G-5861

Subject: Response to Geotechnical Review Comments, Proposed New Residence, 3626 – 90th Avenue SE, Mercer Island, Washington.

Reference: Geotechnical Engineering Investigation, Proposed New Residence, 3626 – 90th Avenue SE, Mercer Island, Washington. GEO Group Northwest, Inc., April 18, 2023.

MERCER ISLAND IGS TOPOGRAPHIC MAP AND ASCE7 HAZARD TOOL REPORT

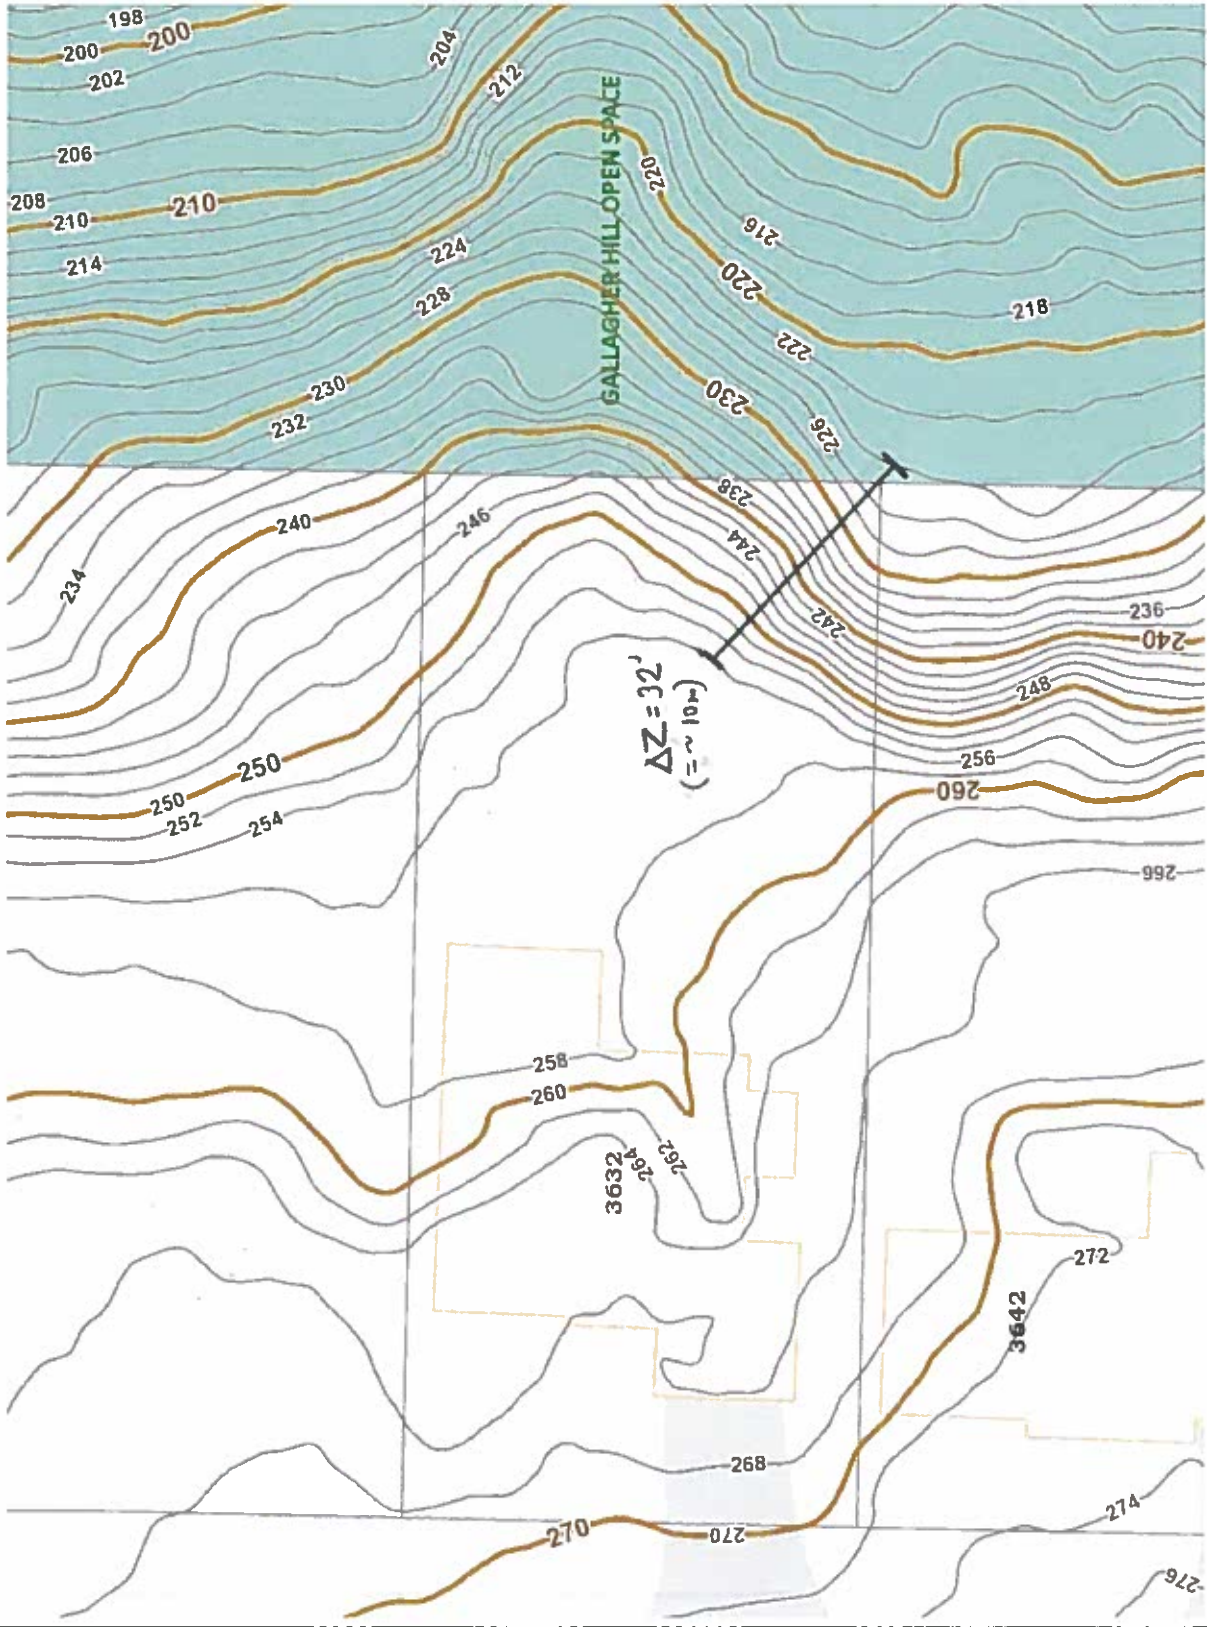
Please include discussion of how the seismic coefficient (0.22) was determined. Please include calculations for review and cite references used to determine the seismic coefficient.

Slope height was assigned using the topographic survey for the site and the City of Mercer Island IGS topographic information enclosed in Attachment A. The average shear wave velocity for the slope mass was assigned as 1,200 ft/s (equivalent to 365 m/ sec), based on this being the value used for soils at the boundary between Site Class C and D soils in ASCE Standard 7 (2016), Chapter 20.

The value for the fundamental site period, T_s was determined per the method in Bray and Travararou (2011). The value for the site spectral acceleration, S_a , for the period of $1.5T_s$ was assigned the value for S_{MS} for the site, obtained from the ASCE 7 Hazard Tool application (the application report is enclosed in Attachment A).

UPDATED SLOPE STABILITY ANALYSIS RESULTS

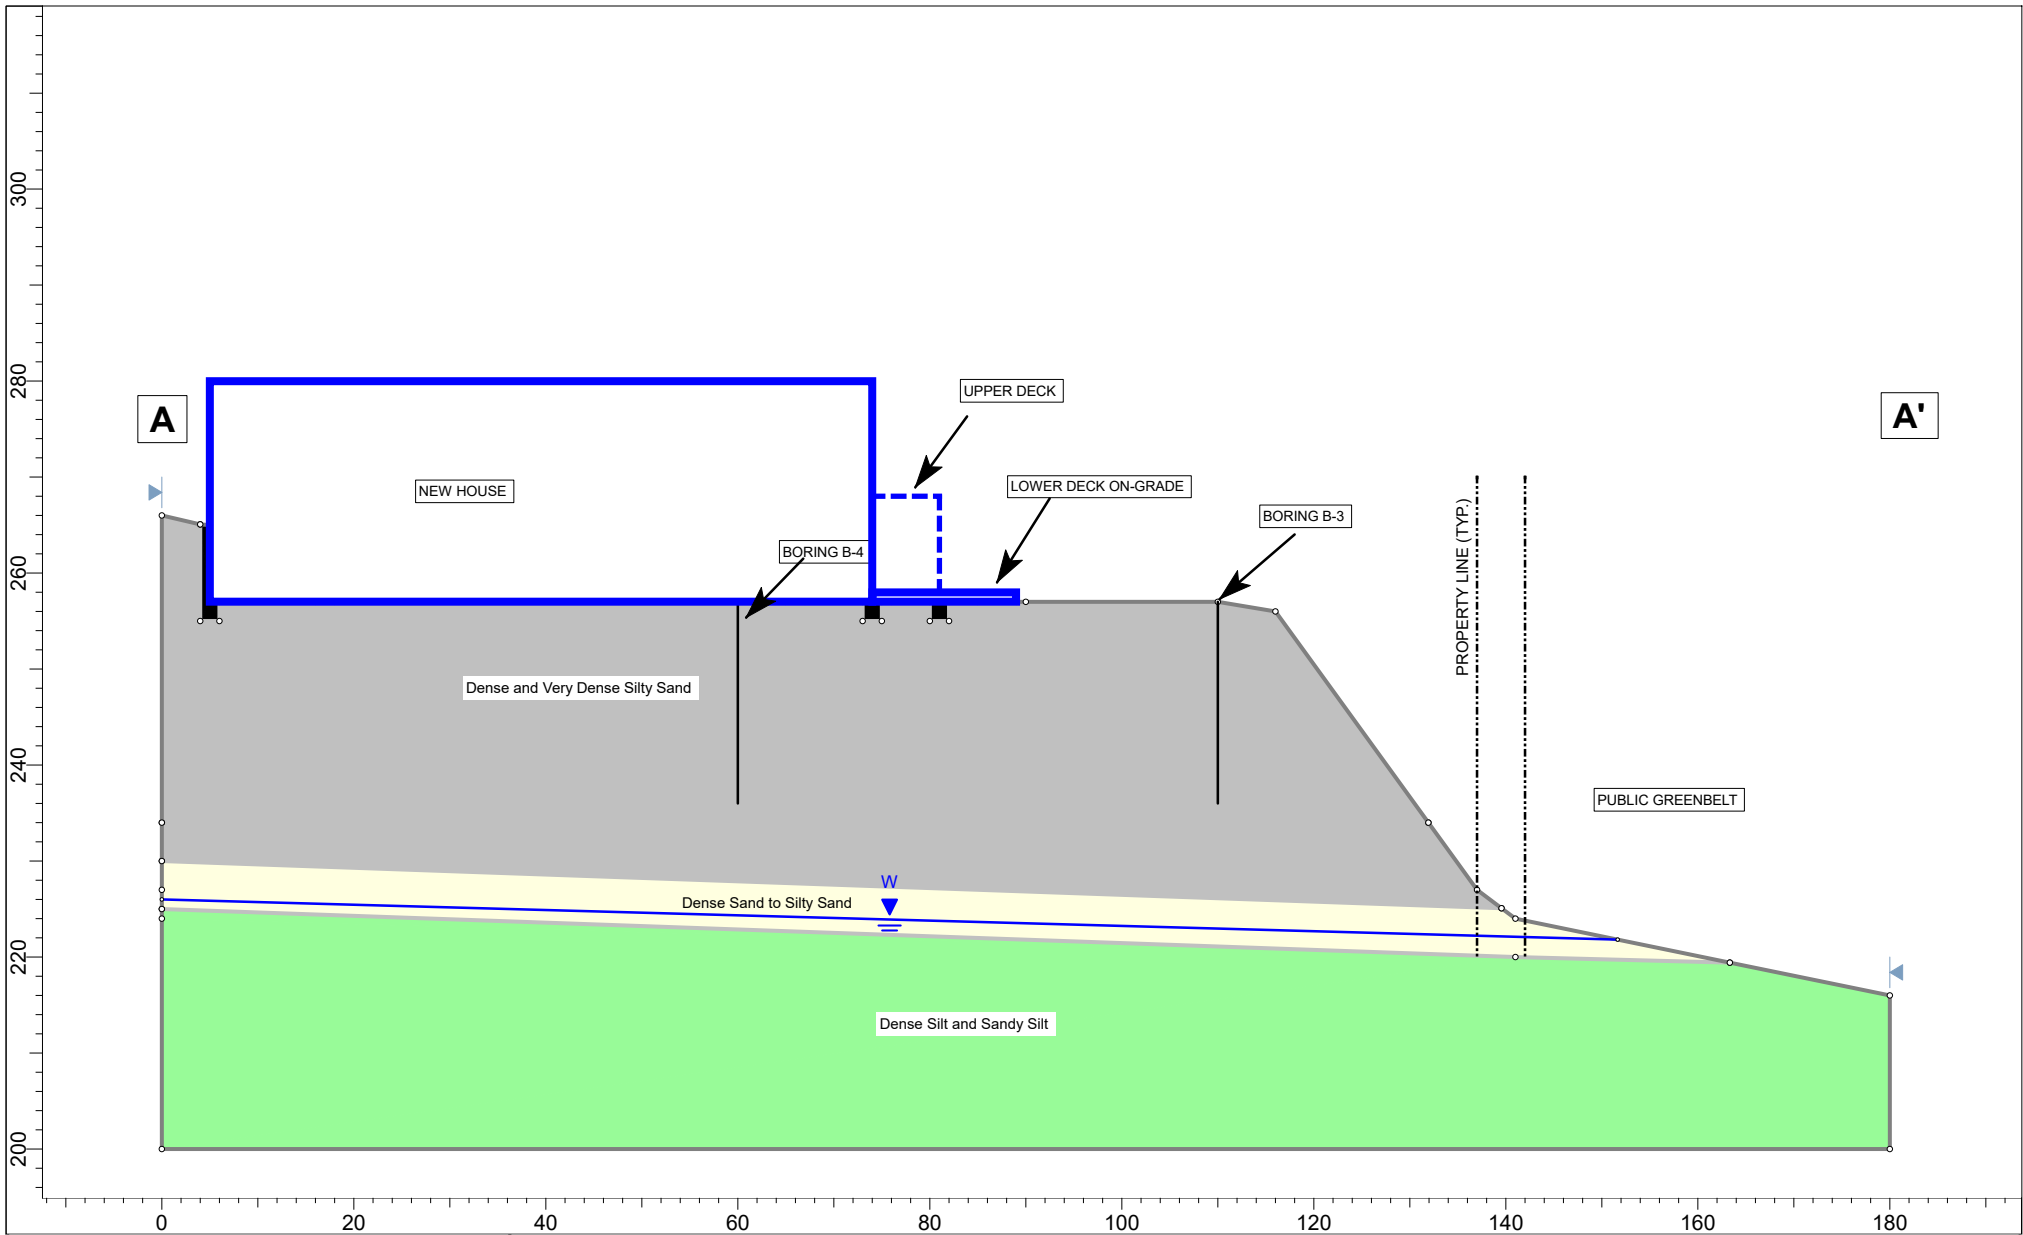
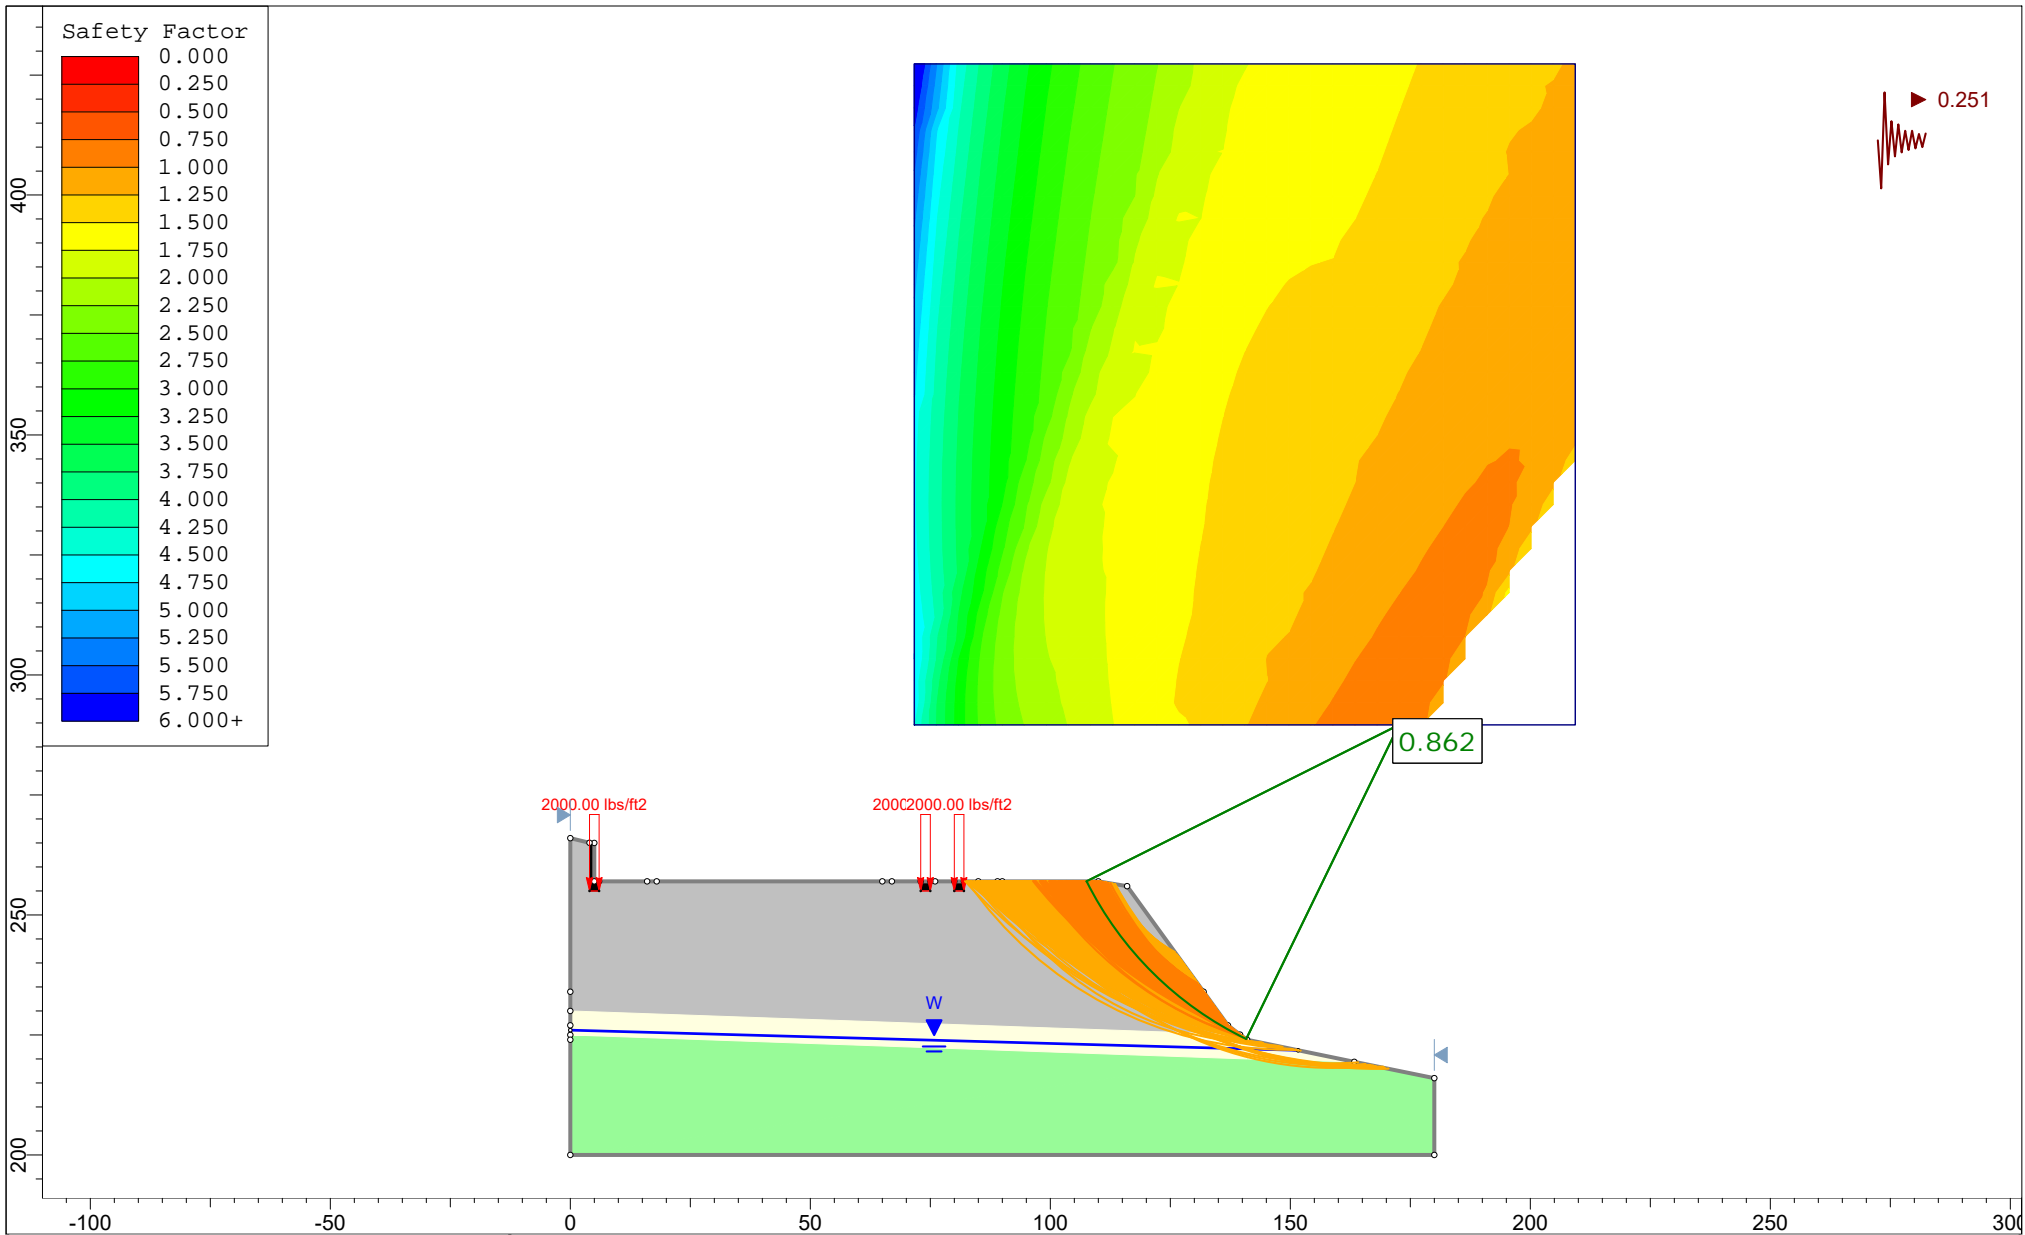
If the use of the seismic coefficient of 0.22 cannot be supported by calculation or technical references citing alternate methodologies please revise seismic stability analyses. Discuss impacts of seismic slope instability, e.g., estimated slope deformations and associated structural impacts. Please provide mitigation recommendations, if

applicable. Please present revised stability analysis results and subsequent recommendations in a report addendum.

Based on findings from the above-described analysis, we updated our slope stability analysis for the project site using the value of 0.251g, for the pseudo-static loading. The results from the updated analysis are presented in Attachment B to this letter.

The results are filtered to illustrate the potential soil movement surfaces having a safety factor of less than 1.2. Bray and Travasarou (2011) note that adding a safety factor to the analysis results may not be warranted, as the determination of k has already considered displacement magnitude and probabilistic occurrence. Nevertheless, we have included the safety factor, as it provides an additional measure of conservatism to the analysis and is consistent with current local practice.

The results indicate that the extents of the potential slope displacement surfaces do not intersect the proposed residence location. The minimum distance between the building foundations and the surfaces is approximately 8 feet; the outermost foundation element shown in the results profile is an exterior deck column footing that is separate from the building.

Based on the analysis findings, it is our opinion that the proposed residence has minimal risk of harm to life safety due to soil displacement from an earthquake as considered in our analysis.
